**RELEASED FOR  
 FABRICATION / INSTALLATION**  
 PPPL Drafting:

Oak Ridge National Laboratory managed for the DEPARTMENT OF ENERGY under U.S. GOVERNMENT contract DE-AC05-00OR22725 UT-BATTELLE, LLC, Oak Ridge, Tennessee PROJECT NAME						
NATIONAL COMPACT STELLERATOR EXPERIMENT VACUUM VESSEL PERIOD INSPECTION AND LEAK CHECK ASSEMBLY						
VERSION NO.	PLANT	BLDG	FL	SHT OF	TYPE	CLASS
5	X-10	5700	3	2 19	A	U
RELEASE LEVEL		SE120-004			REV	
Fabrication					2

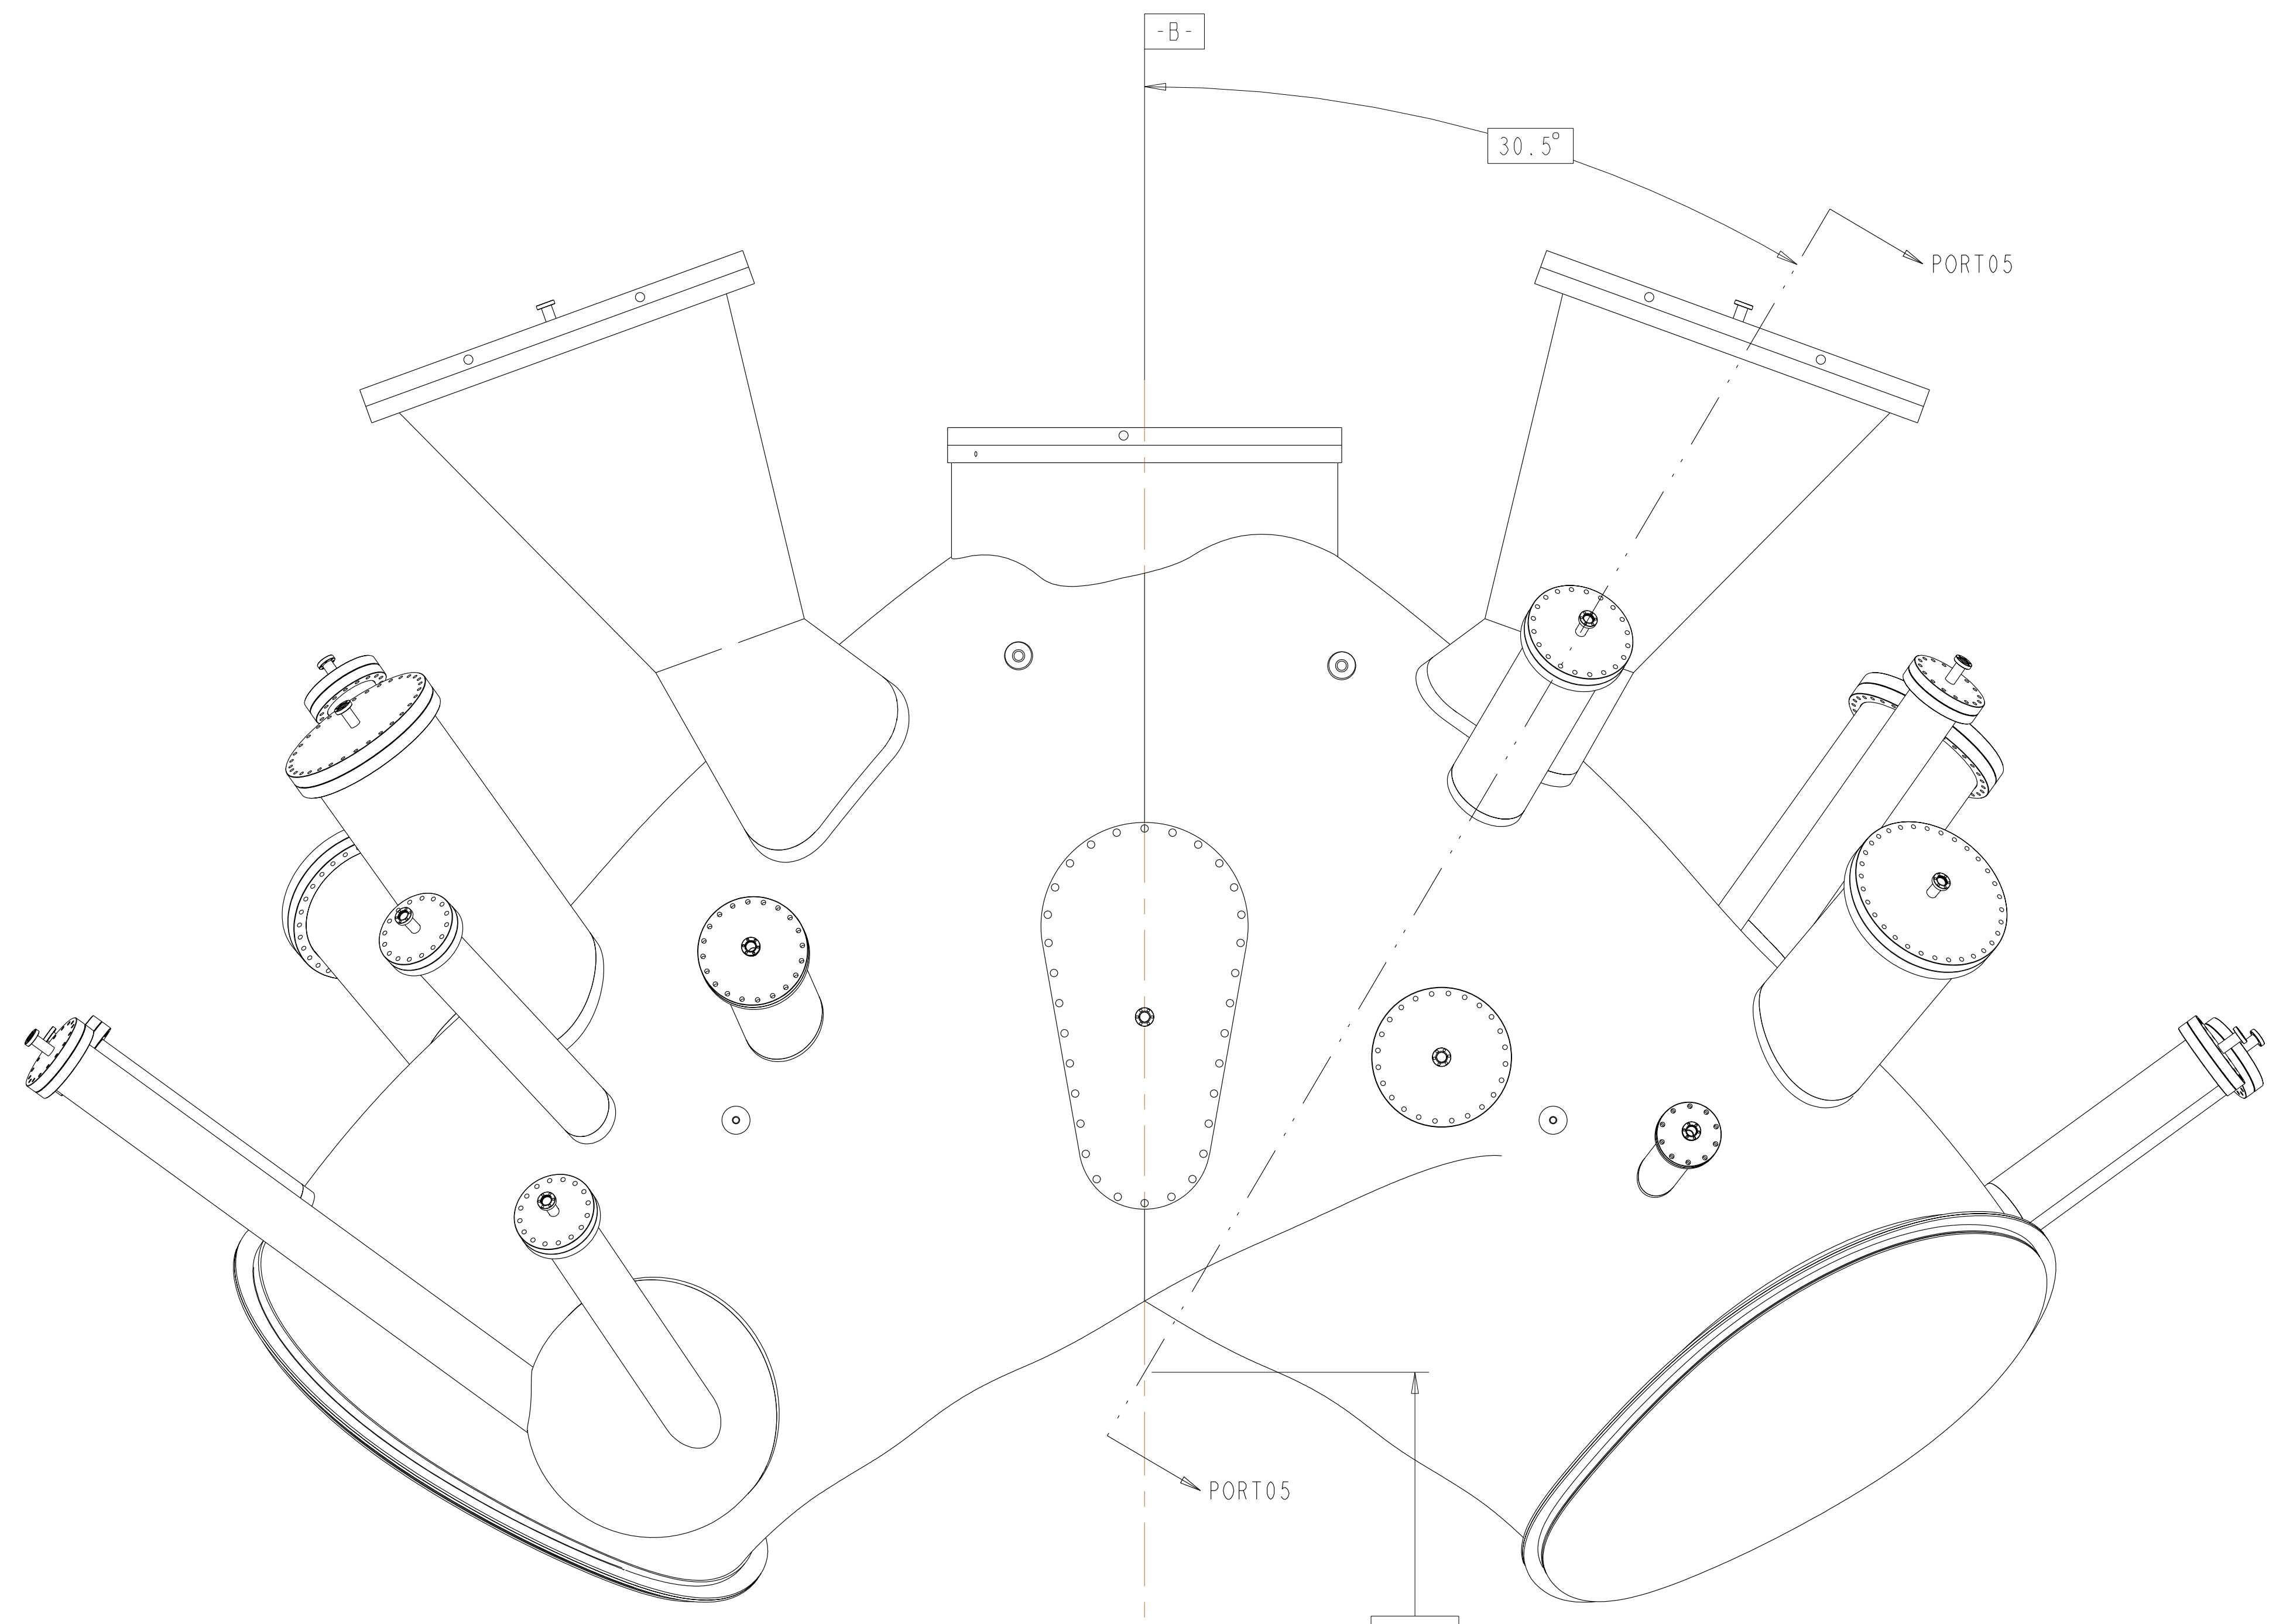
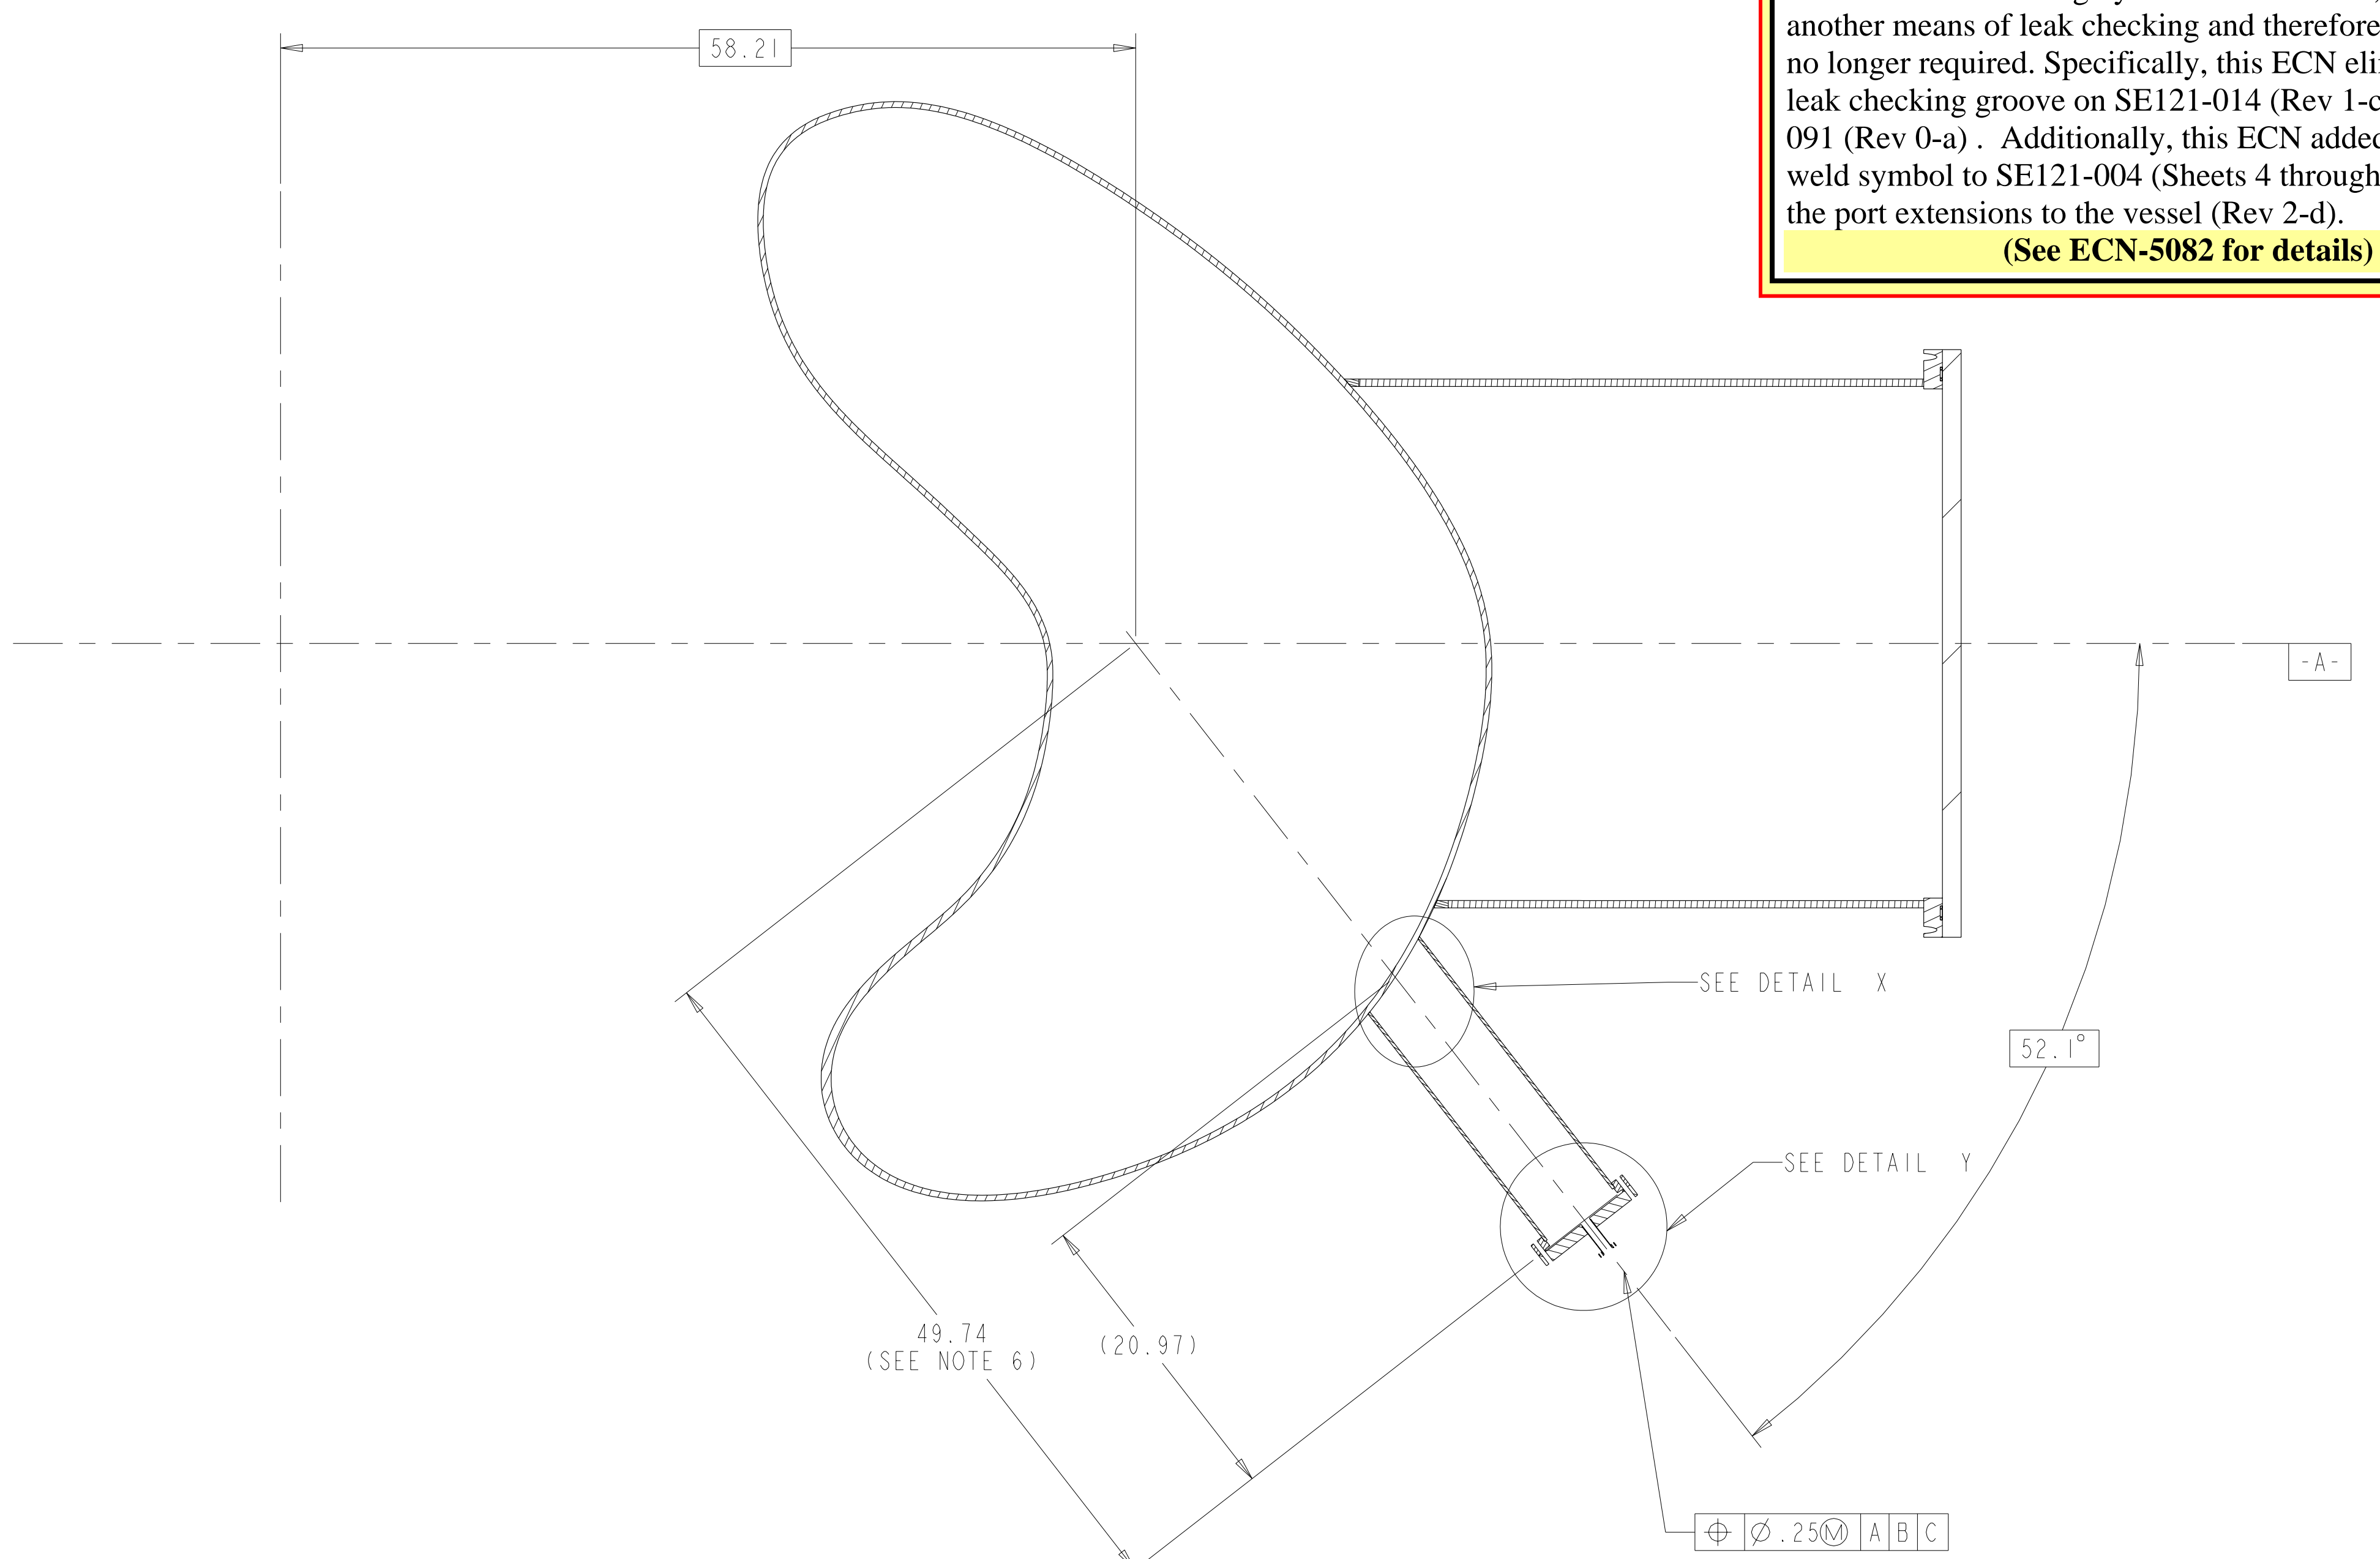
**Rev 2-e: ECN-5021 (RFD-12-017) approved alternate methods for welding the port extensions to the VVSA (See ECN-5021 for details). - Only applicable to VVSA #3 - VVSA #1 and #2 covered by NCR 19464.**

**ECN-5082.** Requirement originally included grooves to facilitate leak checking by vendor. However, vendor elected another means of leak checking and therefore the grooves are no longer required. Specifically, this ECN eliminated the leak checking groove on SE121-014 (Rev 1-c) and SE1221-091 (Rev 0-a). Additionally, this ECN added a missing weld symbol to SE121-004 (Sheets 4 through 19) for joining the port extensions to the vessel (Rev 2-d).  
(See ECN-5082 for details)
